## Mandatory Action Jan. 2017

Inspection of the Horizontal Stabilizer tail attachment brackets

Transportation Safety Board of Canada - **AVIATION SAFETY ADVISORY A1600137-D1-A1**  
**Zenair Zodiac CH-601A—Risk of structural failure of the horizontal stabilizer**

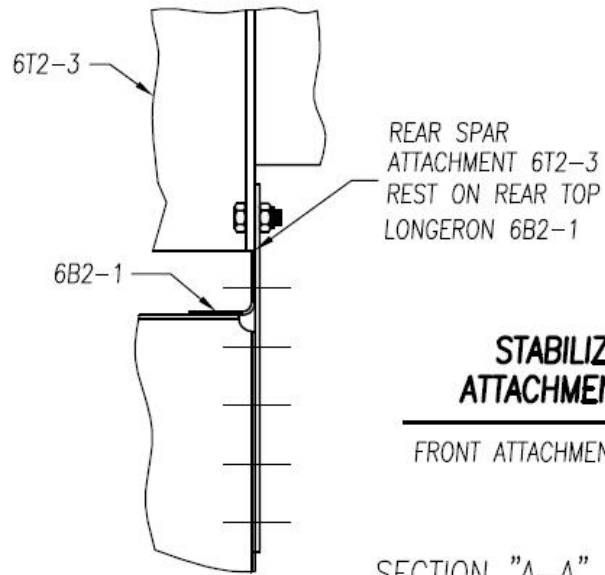
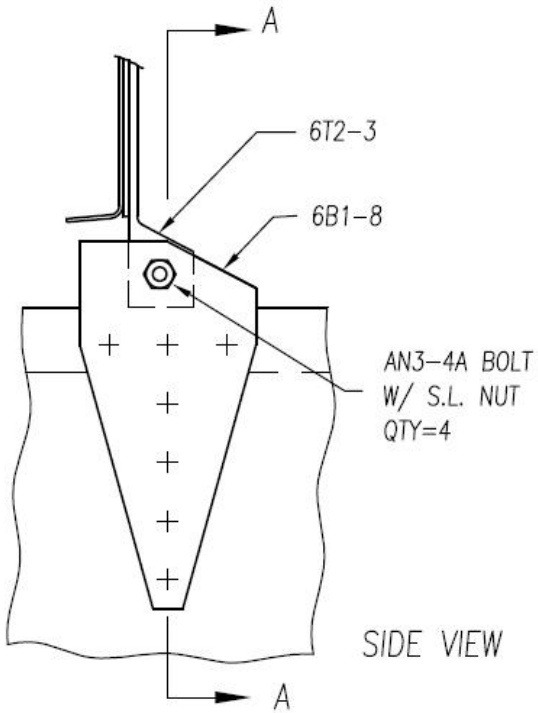
If you are not able to properly inspect inside the H.S. forward attachment brackets and associated rivets, cut out the area as shown in the following sketch. Add a cover plate after inspection as shown. Fasten into place with 18 rivets A4 around the perimeter of the cover plate.

If the brackets are to be replaced, the cut out holes can be made larger. See FAA AC-43-13-1B section 4-32, Figure 4-16 when adding a covering.

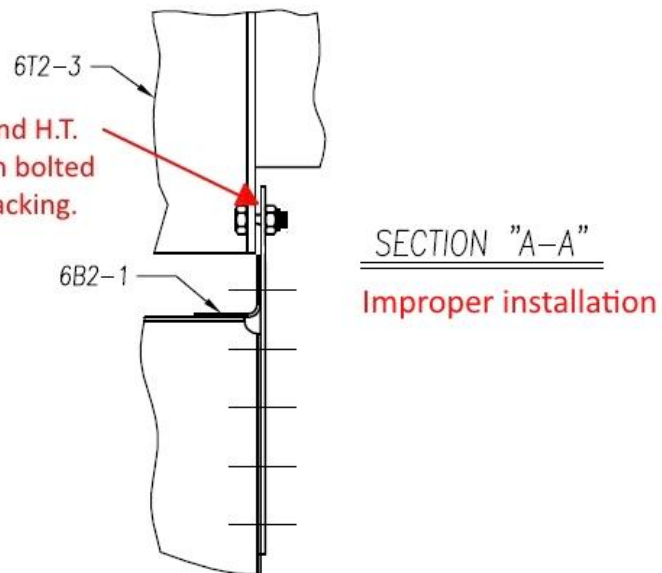
Gap between the fuselage fitting and H.T.  
is not acceptable. Parts will be stressed when bolted  
resulting in possible cracking.

Above assembly drawing is for a typical CH 601 aircraft. Each CH design is different. Use your airframe model blueprints (drawings) and not the above example for inspection and installation.

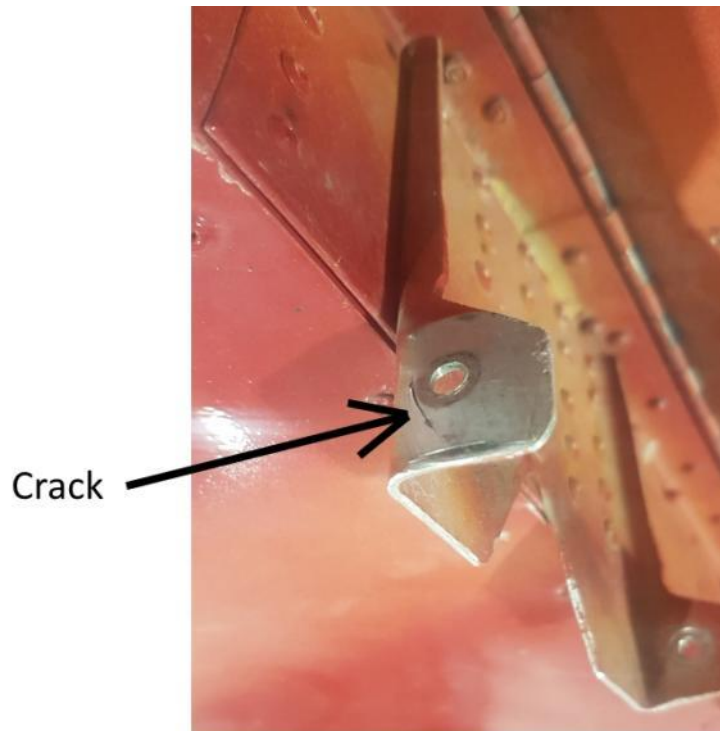
View of H.S. rear attachment bracket. A crack is developing in the part. Part must be replaced.

Strange hole.  
Part must be changed.

View of H.S. front attachment bracket. Bolt hole was not properly drilled. Part must be replaced.

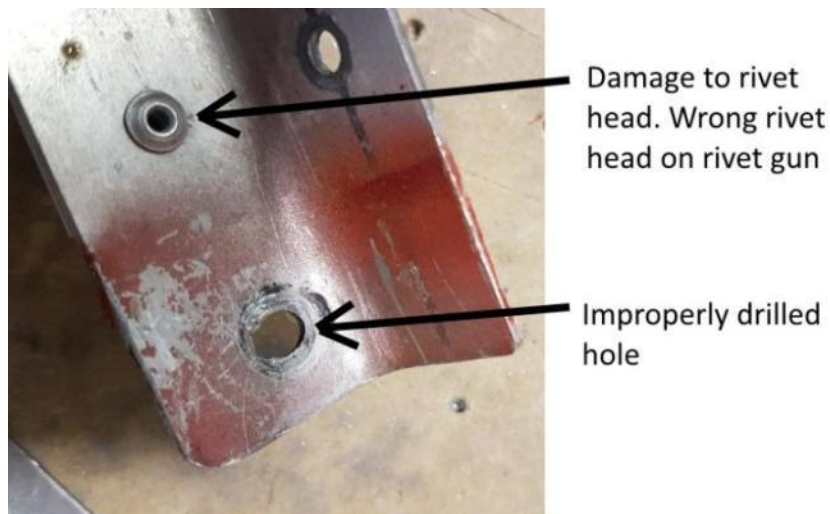
Bracket attaching horizontal stabilizer to fuselage.  
This is not an original bracket.

Above parts must be replaced.

Above part must be replaced.

**Figure 1.** Horizontal stabilizer forward structural attachment—aircraft drawing. (source: Zenair, with digital annotations by the TSB)

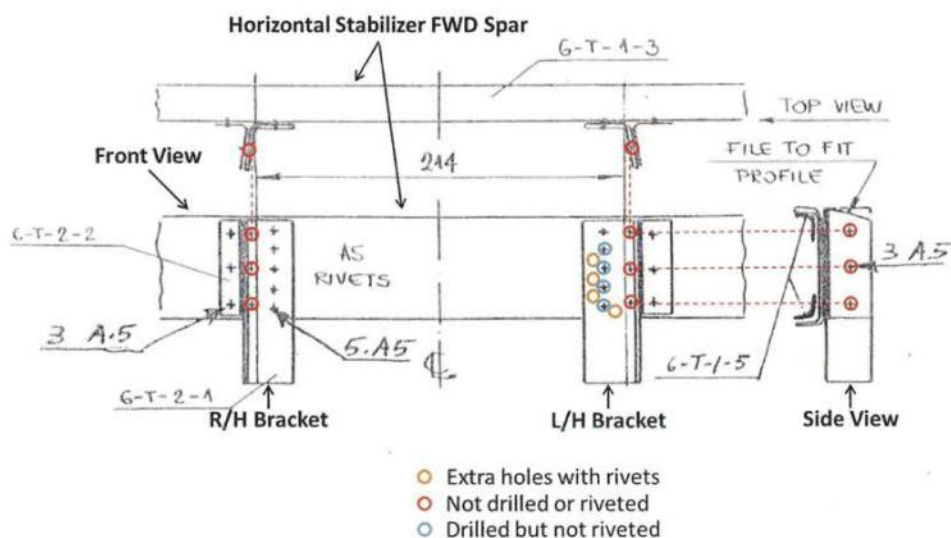
As per the drawing (Figure 1), the horizontal stabilizer forward structural attachment is designed to be constructed by riveting two aluminium angles (attachment bracket 6-T-2-1 and attachment doubler 6-T-2-2) with three rivets back-to-back and connecting the attachment bracket to the front surface of the forward spar (6-T-1-3) with five rivets.

In the actual installation, the three rivets connecting each attachment bracket to the associated attachment doubler were missing and the required holes were not drilled. Four additional holes were drilled through the left attachment bracket and continued through the forward spar. Rivets were installed in all of these additional holes; however, they were only installed in one of the five holes specified in the drawing.

Structural integrity of the horizontal stabilizer forward attachment point was compromised on both sides because of the missing rivets, and the strength of the forward spar itself was reduced because of the extra holes.
